TLE826xE/-2E

Universal System Basis Chip Family

Errata Sheet

Rev. 1.00, 2012-02-28

Figure 1 LH Activation during SBC Sleep Mode Not Permitted

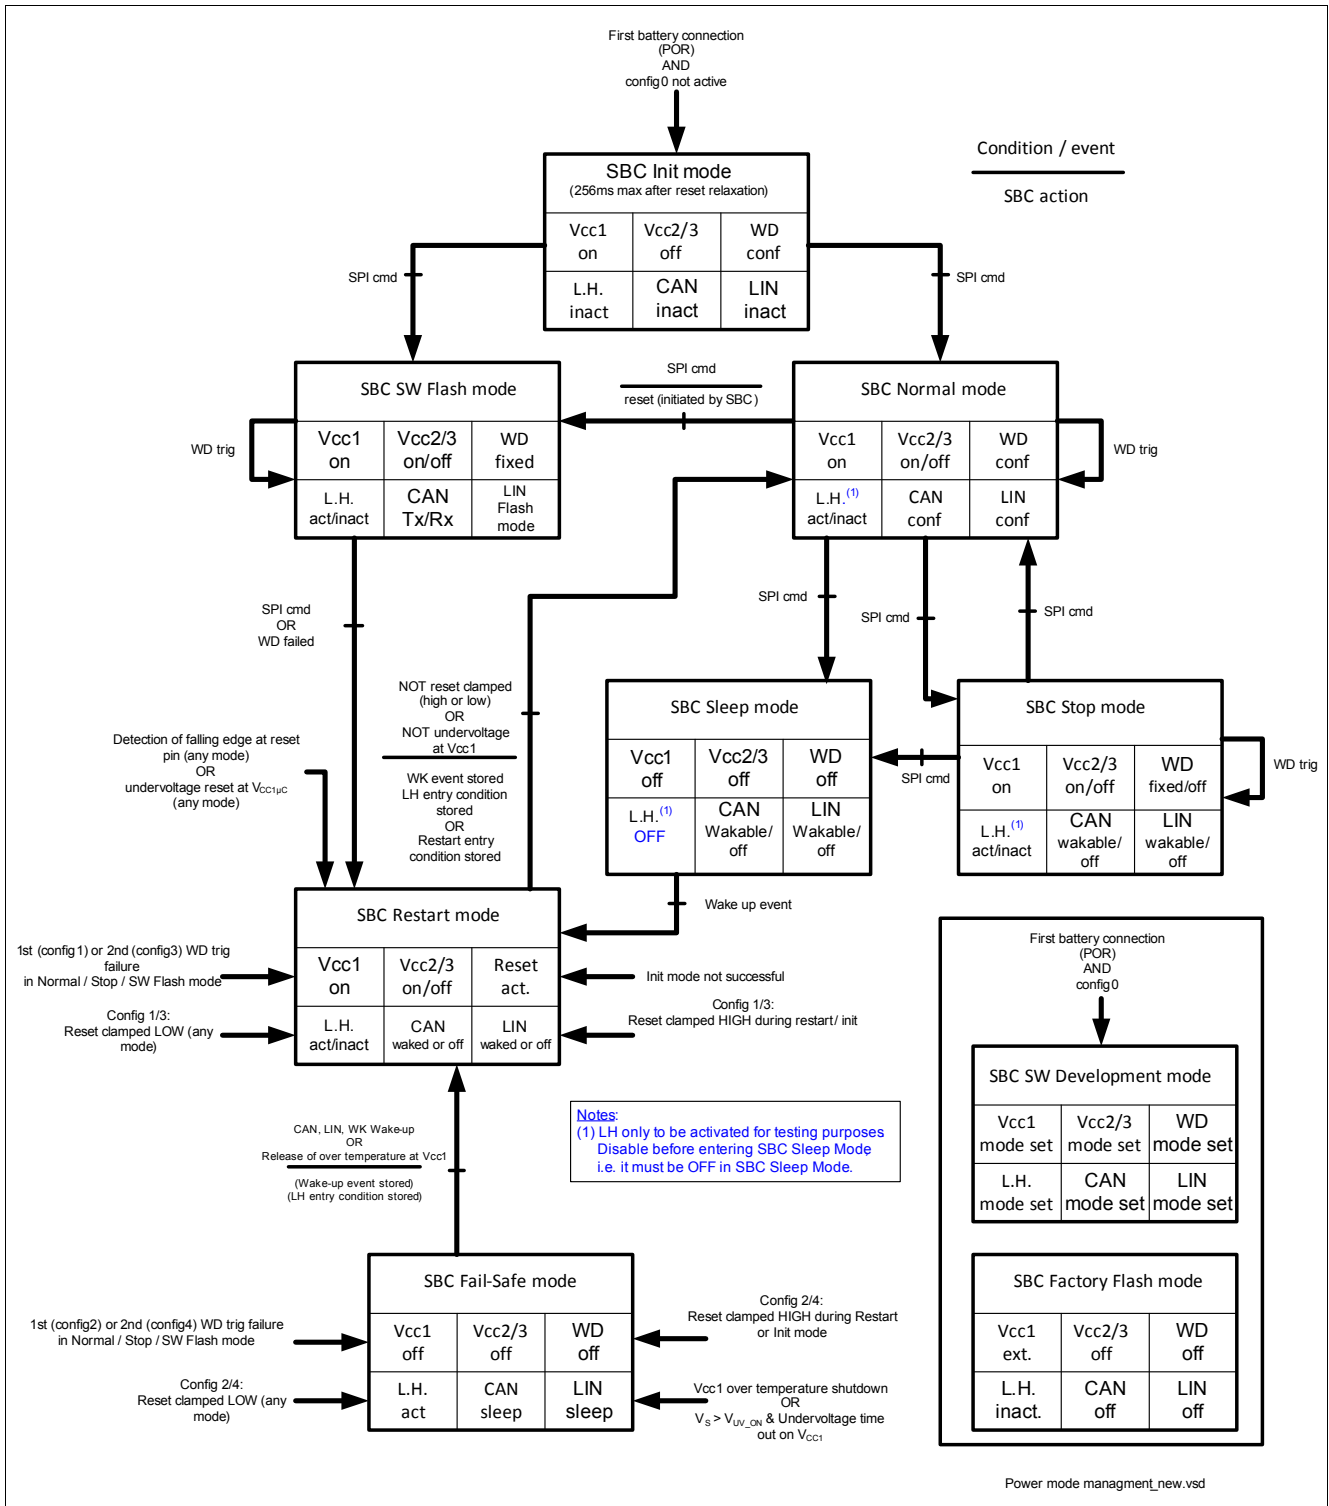
- $V_{cc1_μC}$ undervoltage (UV) comparator can generate the chip-internal signal “no Vcc1_UV” during SBC Sleep Mode after ~4 min
- Digital logic interprets $V_{cc1_μC}$ is enabled and reset output RO is internally set to “HIGH” after reset delay time (only occurs when Limp Home is activated)
- RO driver is not supplied ($V_{cc1_μC}$ is off in SBC Sleep Mode) → “Reset clamped low” (LH[2:0] = 110_B) detected

- SBC detects failure and changes to SBC Restart Mode and switches on $V_{cc1_μC}$, leading to SBC Normal Mode
- LH[2:0] shows 110_B (“Reset clamped”) instead of 000_B
MS[2:0] shows 001_B (coming from SBC Restart Mode) instead of 100_B (coming from SBC Sleep Mode)
RM[1:0] shows 01_B (“Undervoltage on $V_{cc1_μC}$ ”) instead of 00_B

- Do not activate LH before entering the SBC Sleep Mode (see also [Figure 1](#))
- Ensure that LH is disabled before entering SBC Sleep Mode, e.g. after a failure:
 - Check if the LH bit (bit 12 in the SBC Configuration Register CS[2:0] = 100_B) is set
 - If the LH bit is set, then send a valid watchdog trigger. Otherwise the SBC can be sent to Sleep Mode immediately.
 - Disable the LH bit (*Note: this must be a separate SPI command*)

Note: LH will be activated automatically due to a failure during the device operation and is not automatically disabled when entering SBC Normal Mode. Therefore, it must be ensured that LH is disabled before entering SBC Sleep Mode.

Figure 2 Verifying actual device status after coming from SBC Sleep or Fail-Safe Mode

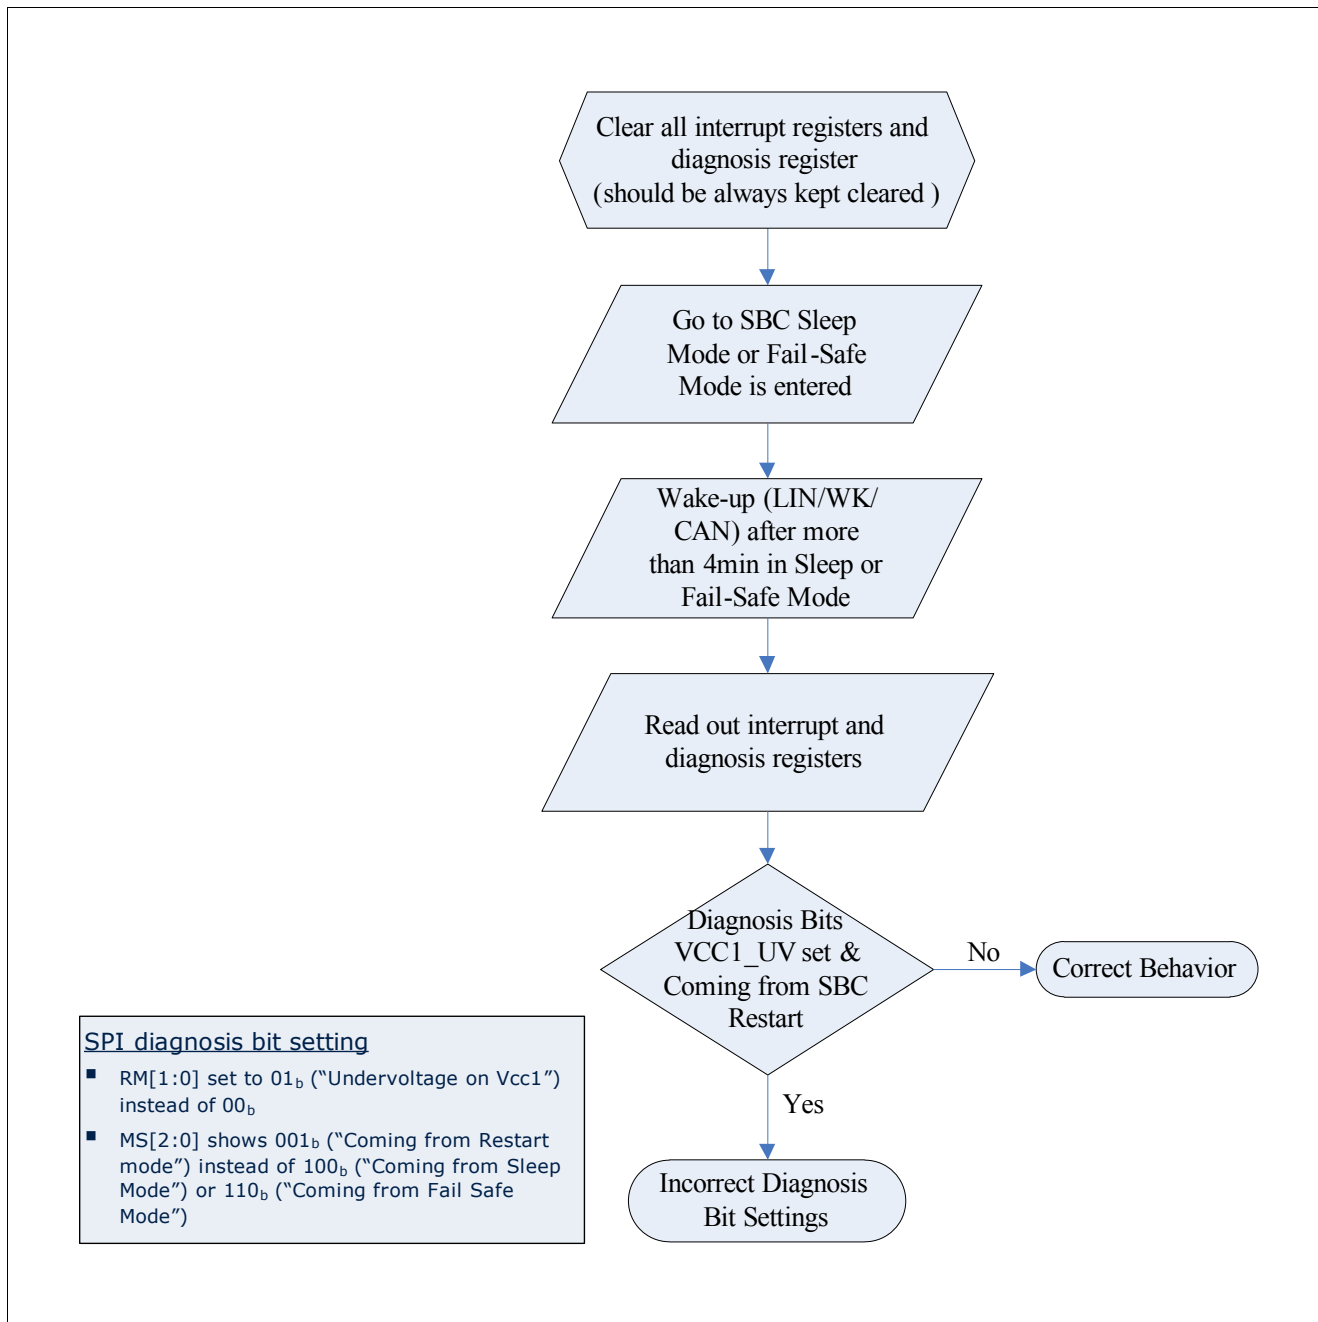
- $V_{cc1_μC}$ undervoltage (UV) comparator generates the chip-internal signal “no Vcc1_UV” during SBC Sleep or Fail-Safe Mode (see also [Chapter 2.1](#)) but device will only wake up by an external wake-up event on CAN, LIN or WK as defined in the datasheet.
- At the SBC mode transition from SBC Sleep or Fail-Safe Mode to Restart Mode $V_{cc1_μC}$ is enabled and $V_{cc1_μC}$ UV comparator shows correct signal “Vcc1_UV”. This transition from “no Vcc1_UV” to “Vcc1_UV” causes an unexpected failure signaling and the SPI bits RM[1:0] set to 01_B.

- RM[1:0] set to 01_B (“Undervoltage on $V_{cc1_μC}$ ”) instead of 00_B
- MS[2:0] shows 001_B (“Coming from Restart Mode”) instead of 100_B (“Coming from Sleep Mode”) or 110_B (“Coming from Fail-Safe Mode”) respectively

The same set of SPI responses can only be reached when $V_{cc1_μC}$ undervoltage occurs in SBC Normal or SBC Stop Mode and the Wake register wasn’t cleared before.

- Always clear interrupt and diagnosis (Limp Home) registers before entering SBC Sleep Mode
- Save last SBC State in microcontroller, e.g. SBC was sent to SBC Sleep Mode
- Read out interrupt and diagnosis (Limp Home) registers after wake-up (see [Figure 2](#))

Figure 3 Expected behavior of RO output with reset delay time

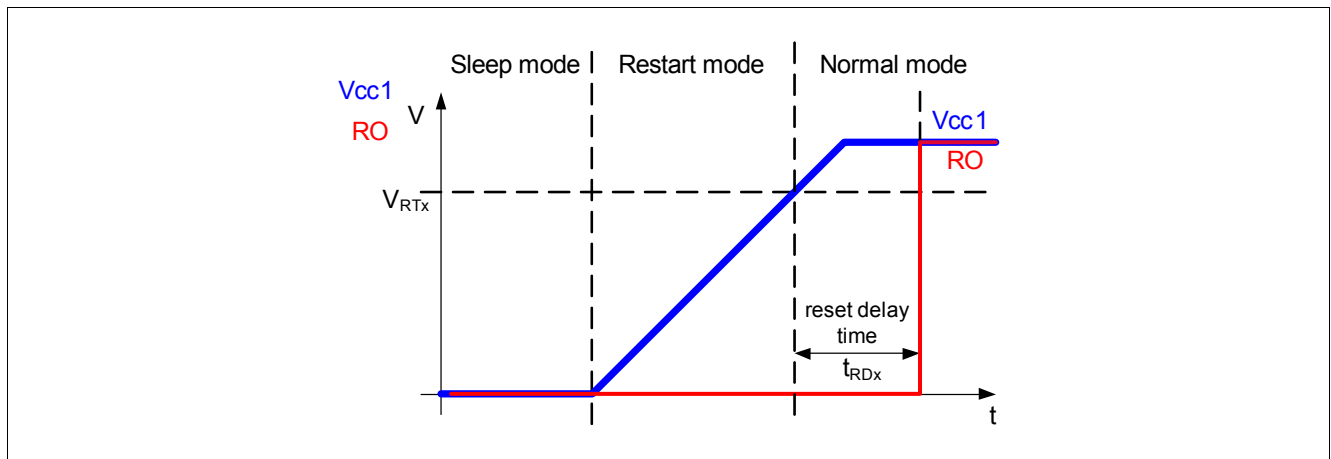
- The expected behavior of the reset output RO is shown in [Figure 3](#). When $V_{cc1_μC}$ reaches the selected V_{RTX} threshold the selected reset delay time (t_{RDx}) is started. RO is released after t_{RDx}

Figure 4 Missing reset delay time after coming from SBC Reset Mode

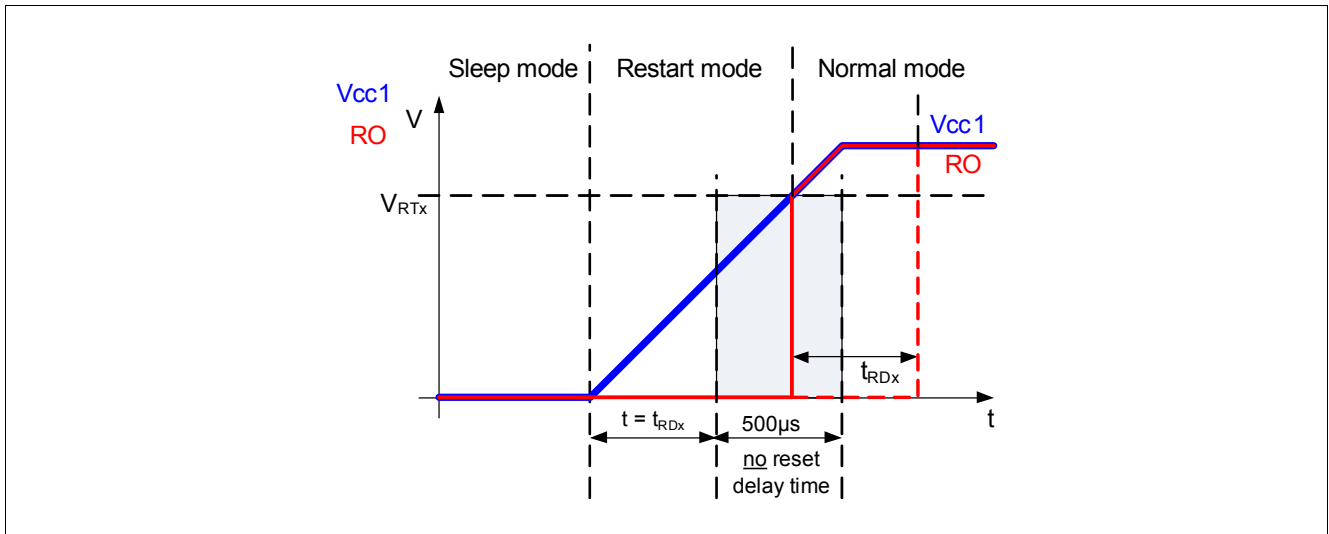
- Under conditions as described in [Chapter 3.1](#) no reset delay time will be triggered. See also [Figure 4](#)
- When $V_{cc1_μC}$ is ramping during SBC Restart Mode an internal counter starts running to test for the “Vcc1 undervoltage time-out” behavior. However, the same counter is used for the reset delay time t_{RDx} . See also [Chapter 3.3](#)

- When the counter content shows the end of the reset delay time when $V_{cc1_µC}$ is crossing the V_{RTx} threshold, RO is set to “HIGH” already after 10µs (typ) instead of configured t_{RDx}

- The critical range in time (see **Figure 4**) is the period between t_{RDx} and $t_{RDx} + 500 \mu s$
- When $V_{cc1_µC}$ exceeds V_{RTx} during that time, the reset delay time is skipped and RO is release already after 10µs (typ.)
- The critical range for the external capacitor at $V_{cc1_µC}$ and t_{RD2} selected can be calculated (assuming the capacitor is discharged):

- Select the long (default) reset delay time t_{RD1} (in that case $C_{crit} > 185 \mu F$). Changing the reset delay time does not affect any other behavior of the SBC.
- The selected reset threshold V_{RTx} has a small influence only

Figure 5 Simplified timing diagram (not to scale) of a dominant CAN bus signal longer than $t_{\text{BUS_TO,max}}$. The SPI CAN Fail Bit is set

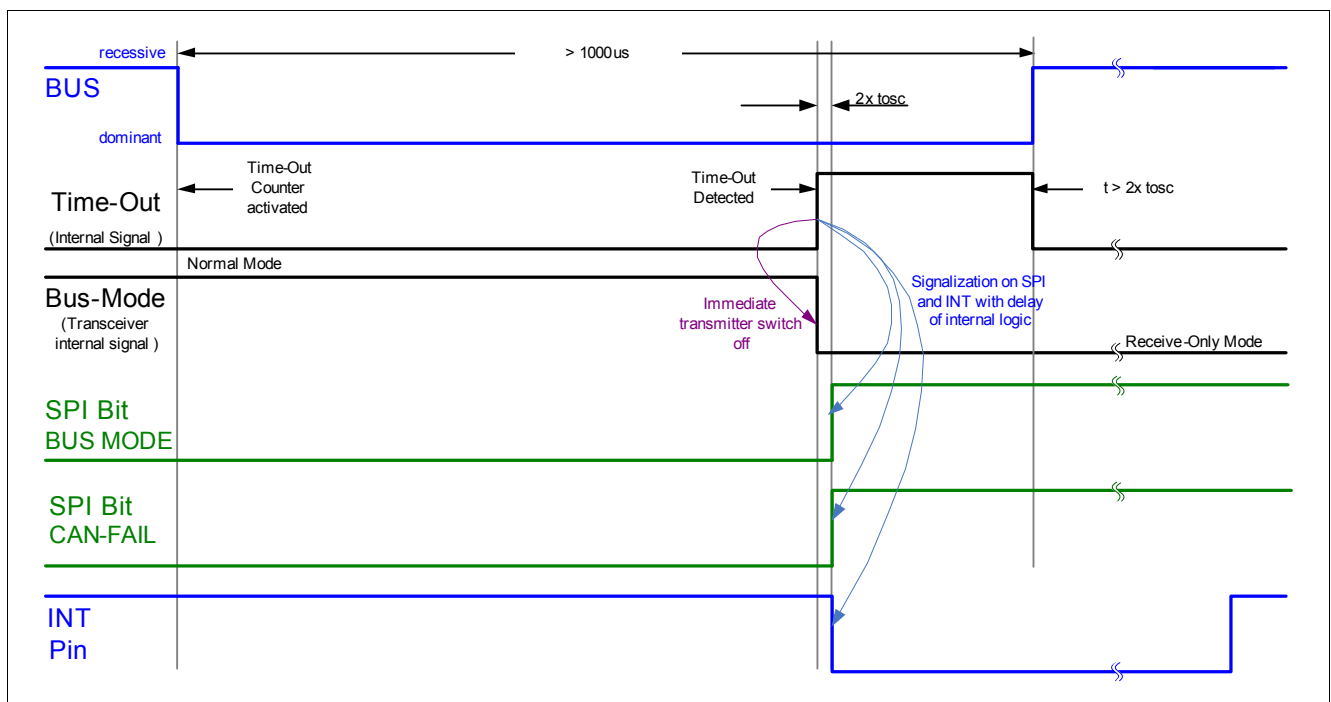
The SPI bus failure bits are set accordingly if the detected time-out condition is valid for a sufficient time (>2 clock cycles $\approx 8\mu\text{s}$). As shown in **Figure 5**, this is the case if the dominant time-out condition is valid longer than the maximum time-out detection period $t_{\text{BUS_TO}}$.

Figure 6 Simplified timing diagram (not to scale) of a dominant CAN bus signal in the range of 300 -600us. No SPI CAN fail bit is set

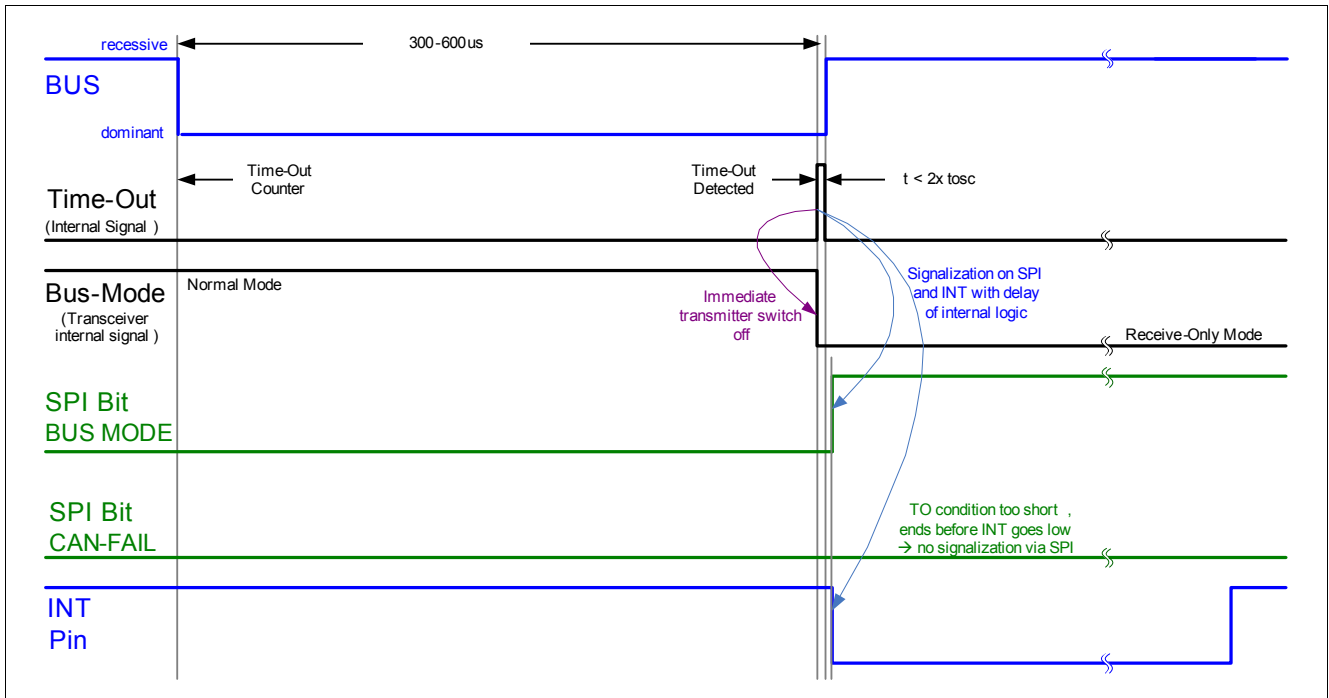
However, it could occur that a CAN or LIN dominant time-out failure¹⁾ is not always set in the respective SPI register for pulses shorter than the maximum time-out detection period $t_{\text{BUS_TO}}$.

If the time-out condition disappears shortly after the detection (1-2 clock cycles) it is possible that the SBC will capture the time-out event but not set the corresponding SPI flag. The INT pin is properly toggled, the transceiver is properly set into Receive Only Mode. However the SPI flag is not set. This behavior will occur for dominant CAN signals within the range of $300\mu\text{s}$ and $600\mu\text{s}$ (for LIN signals between 10ms and 14ms). A timing diagram showing this behavior is shown in **Figure 6**.

This behavior will also be seen when the transceiver is switched again to Normal Mode (from Receive Only Mode) during the dominant pulse and when the remaining dominant period falls within the above mentioned range.

- Read the status of the communication setup register (101) to check if the transceivers have changed modes (i.e. from Normal to Receive Only Mode).
- If this is the case, then a bus failure has occurred and the microcontroller must switch the transceiver back to normal mode if applicable.
- If the mode of the transceivers is unchanged, then another ghost interrupt has occurred caused by a register read out while INT was HIGH (not a bus dominant time-out). If the interrupt registers are all '0', then the INT trigger should be ignored by the software.
